NATIONAL NUCLEAR SAFETY REPORT
ANSWERS TO QUESTIONS OR COMMENTS - **ARGENTINA** - 2017

ARGENTINEAN NATIONAL REPORT
FOR THE CONVENTION ON NUCLEAR SAFETY
ANSWERS TO QUESTIONS OR COMMENTS - February 2017

ARGENTINEAN NATIONAL REPORT
FOR THE CONVENTION ON NUCLEAR SAFETY
Seventh Report - **ANSWERS TO QUESTIONS OR COMMENTS**

Figure 1 – Embalse Containment Water Level vs Water Volume [Up to 5 m]

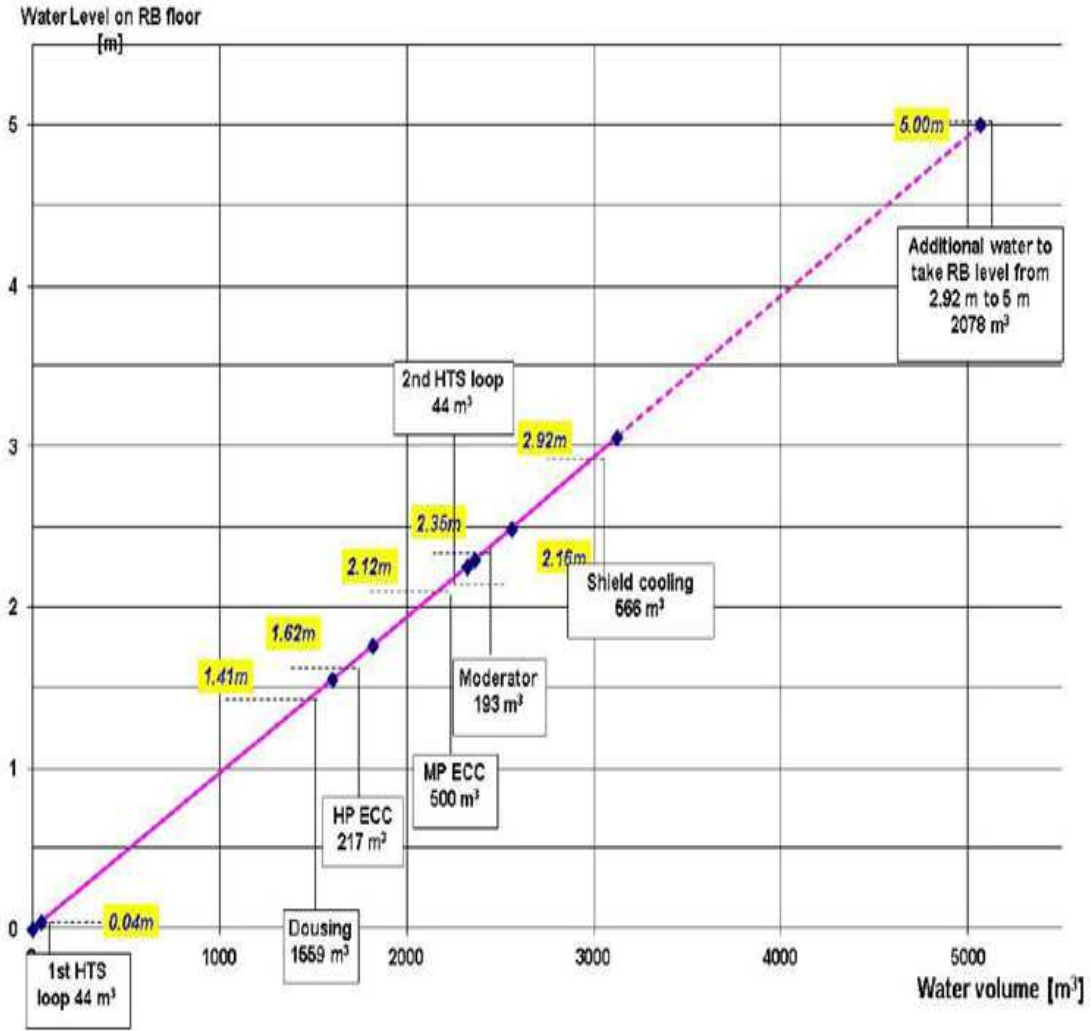
Question

MP ECC: Medium Pressure Emergency Core Cooling
